## MEMORANDUM

**Subject:** **Superposition Modeling – Summary Points**

**To:** Abby Ostovar and Derrik Williams, Montgomery & Associates  
**CC:** Nancy Isakson, Salinas Valley Water Coalition  
Eric Robinson, Kronick Moskovitz Tiedemann & Girard  
Piret Harmon and Emily Gardner, SVBGSA  
Bob Abrams, Aquilogic  
**From:** Dwight L. Smith, PG, CHg, Principal Hydrogeologist  
**Date:** October 18, 2025  
**Subject:** **Technical Review Comments on Montgomery & Associates' Superposition Modeling  
Technical Memorandum dated August 22, 2025**

**Subject: Comments on Montgomery & Associates draft Memorandum, “Results of Computer Modeling Agreement for SVWC and SBWA,” dated August 22, 2025  
Project No.: 018-09**

Figure 2-1. Upper Valley Pumping Off Scenario Compared to Pumping Baseline - Average Groundwater Level Difference for 1980-2022

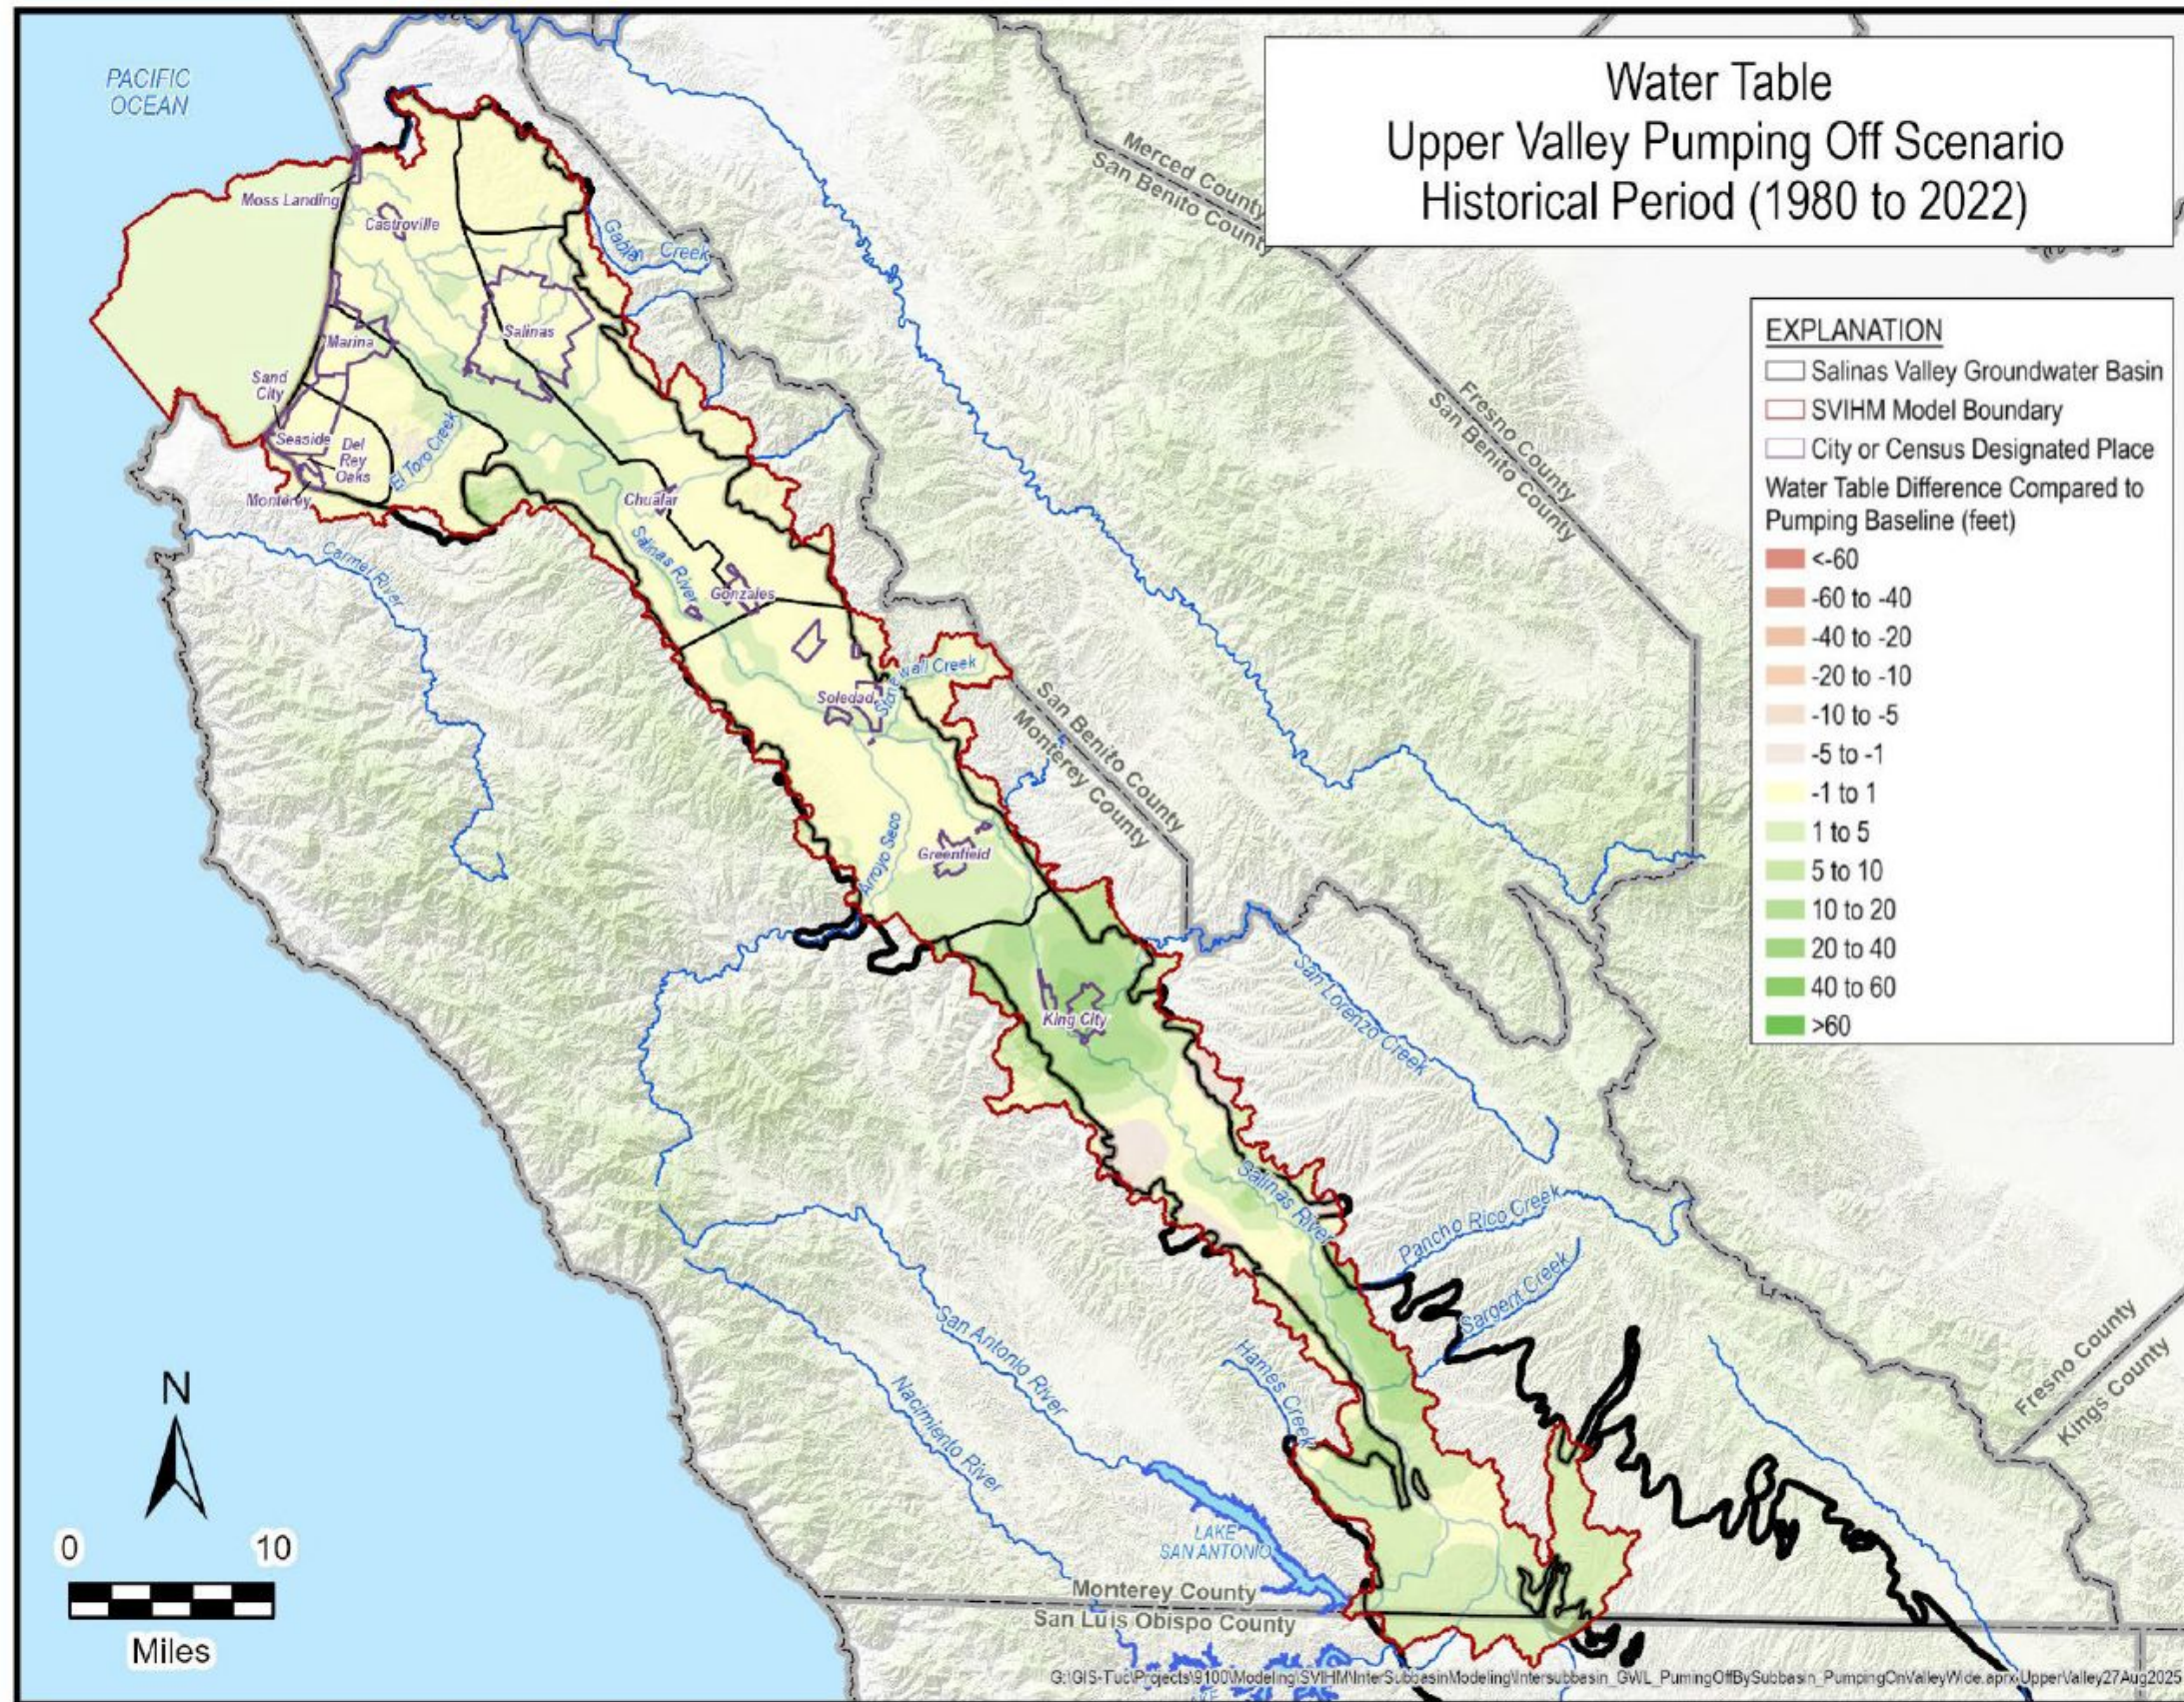
The figures in the draft M&A memorandum are generally informative. However, Figures 2 through 5 and Figures 9 through 12 do not show the results of interest. These figures show the groundwater elevation changes in the subbasin for which pumping was turned on or off. They do not show the impact of pumping in one subbasin on water availability in adjacent and downgradient subbasins. M&A provided draft "replacement figures" at **aquilogic's** request but did not update their draft memorandum.

Further, the color ramps used for Figures 2 through 5 and Figures 9 through 12 make it difficult to understand the modeling results, because the shades of green or red are nearly identical for several of the contour intervals. For example, these figures make clear that pumping in the UV and FB lowers groundwater levels in the 180/400. However, the magnitude of the impacts cannot easily be discerned. We suggest here that labeled contour lines be superimposed on the color shading.

The replacement figures are particularly difficult to decipher, due to the issues noted above with the color ramp, as well as the scale of maps. **Aquilologic** suggests that each figure should be split into three parts. These parts should zoom in on: (1) the 180/400 and ES; (2) the FB; and (3) the UV. The revised replacement figures should be included in a revised draft of the M&A August 25, 2025 draft memorandum.

**FIGURE 1**  
 Historical & Aquifer Full Baseline Maps  
 Superposition Model Testing

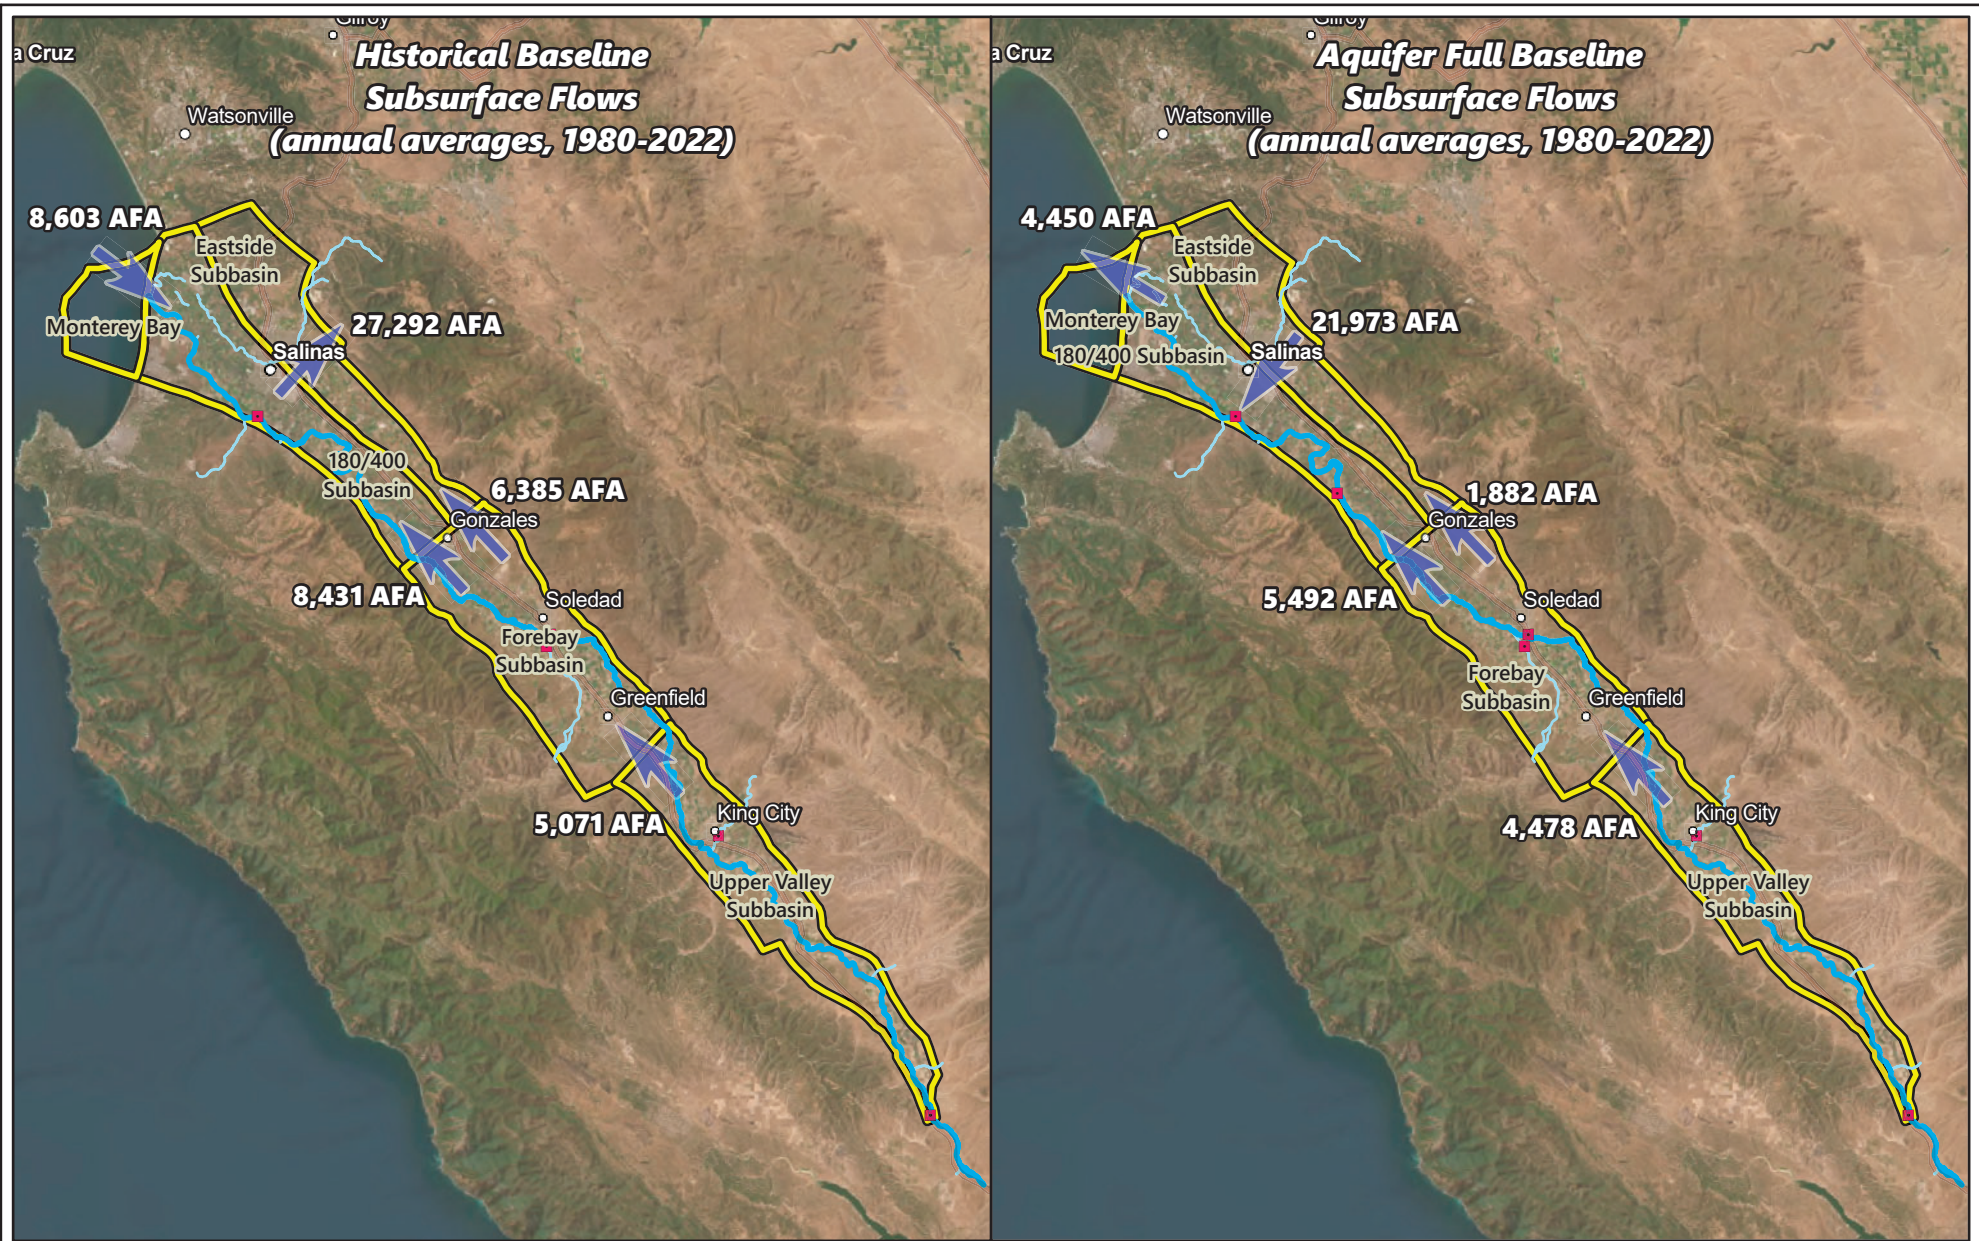
**Figure 1** illustrates the model simulated subsurface flows between the Upper Valley, Forebay, Eastside and 180/400 subbasins for the two baseline conditions from which superposition testing is compared. The left pane shows the simulated average annual subsurface flows between subbasins that has historically occurred. The right pane shows the simulated subsurface flows between subbasins for a baseline condition where no pumping has occurred in any subbasins. All values are in units of acre-feet per year (AFA) as averaged over the modeled years of 1980-2022. Under the historical baseline, an average of 5,071 AFA flows from the Upper Valley to the Forebay Subbasin; 8,431 AFA flow from the Forebay to the 180/400 Subbasin, and 6385 AFA flows from the Forebay to the Eastside Subbasin; 27,292 AFA flows from the 180/400 to the Eastside Subbasin; and 8603 AFA flows from the bay into the 180/400 Subbasin as seawater intrusion.

**FIGURE 2**

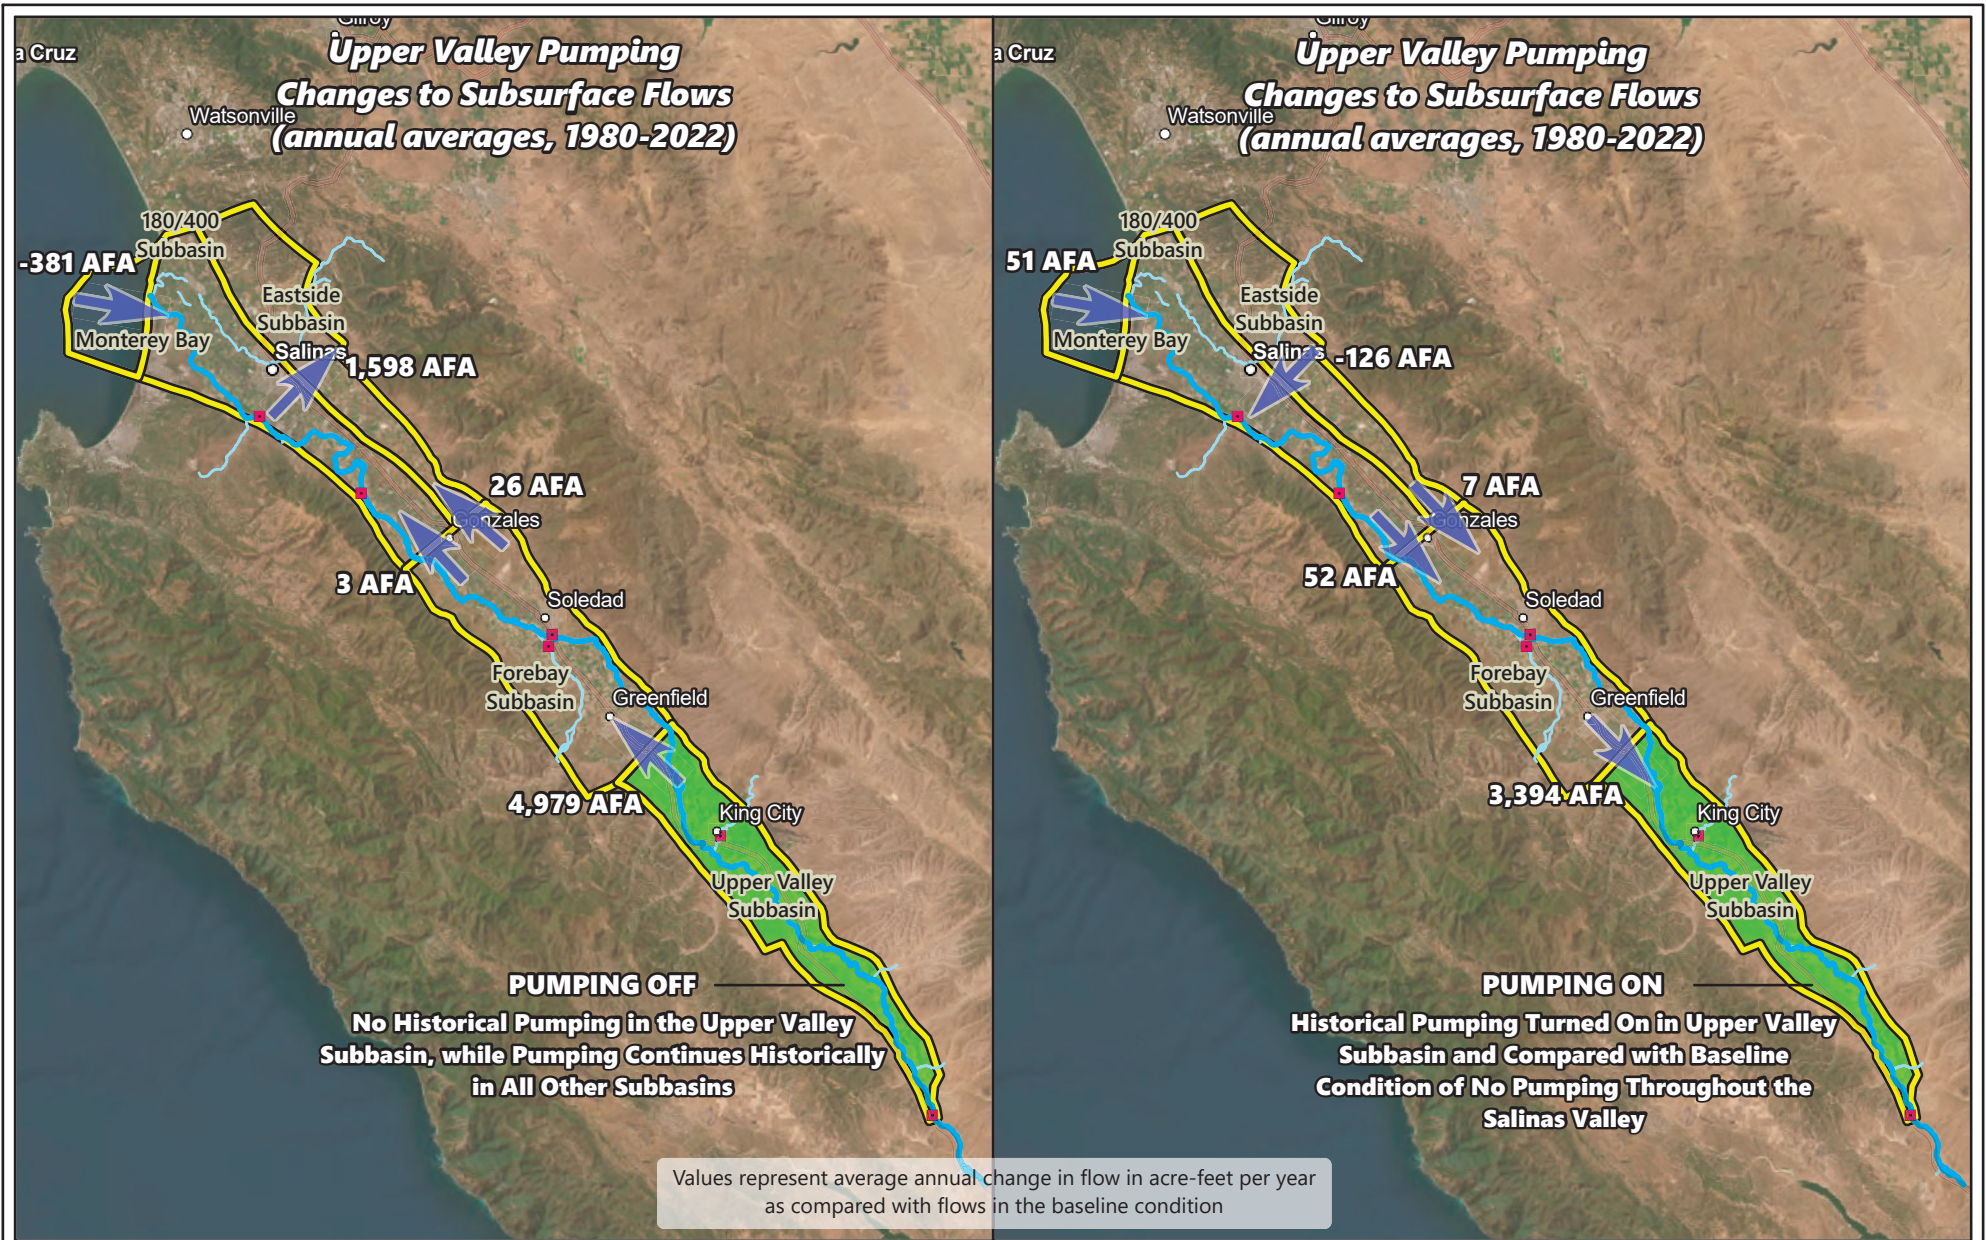
The **Figure 2** left pane illustrates how much the subsurface flows are simulated to change if there had been no pumping from the Upper Valley Subbasin over the entire historical period. There is a simulated increase in subsurface flow from the Upper Valley to the Forebay Subbasin of 4,979 AFA; a simulated increase in subsurface flow from the Forebay to the 180/400 and Eastside Subbasins of 3 and 26 AFA, respectively; a simulated increase in subsurface flow from the 180/400 to the Eastside Subbasin of 1,598 AFA; and a reduction in seawater intrusion to the 180/400 Subbasin of 381 AFA. The changes under the "full aquifer" baseline where the starting point is no pumping anywhere in the valley, then pumping is

turned on in the Upper Valley produces comparable results, but the direction of subsurface flows comparison are presented changes (note direction of arrows in the figures).
